ADDENDUM #5

March 3, 2011

Re: Harrisburg Area Community College
Public Safety Center – Law Enforcement Complex & Site Improvements
Solicitation # 11-13

From: Eastern PCM, LLC
Construction Manager – HACC
645 N. 12th Street, Suite 200
Lemoyne, PA 17043

ADDDENDUM #5
 DRAWING REF AB2.1

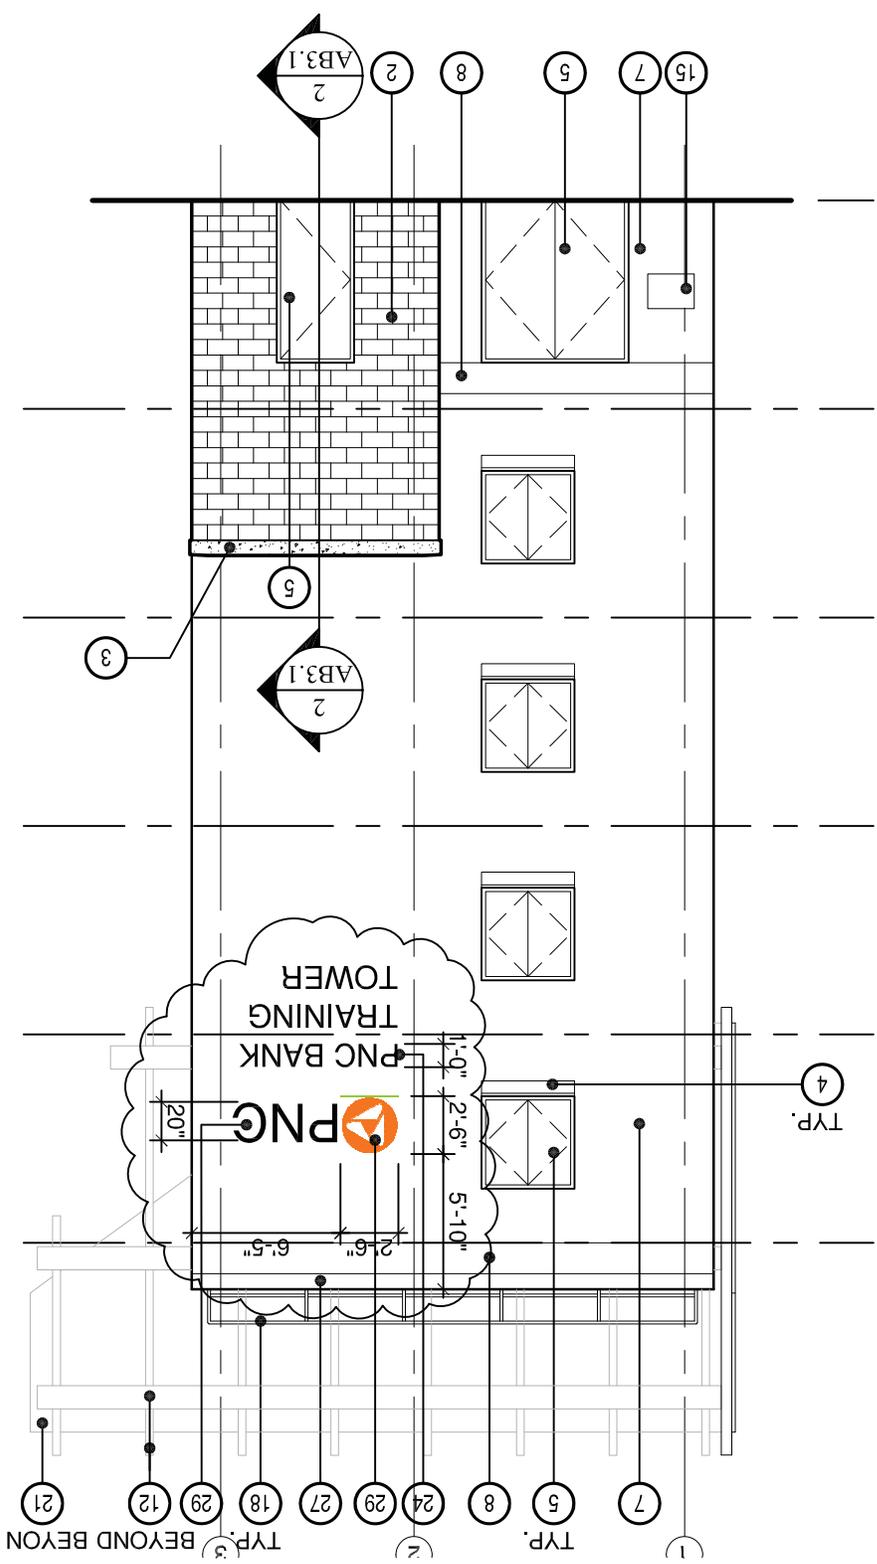
F. Drawing AB2.1

- a. REVISE as identified in sketch A-1, attached to this Addendum #5.
- b. ADD the following General Note: "All exterior aluminum letters, numbers and logos shall be fabricated hollow."
- c. ADD the following General Note: "Color selection for all exterior aluminum letters, numbers and logos shall be selected by architect during construction from full range of manufacturer available colors."
- d. REVISE lettering in Drawing 5/AB2.1 and 7AM2.1 to be 1" Thick Fabricated Hollow letters mounted $\frac{3}{4}$ " off face of building. Backside of Aluminum letters, numbers and logos may be open.
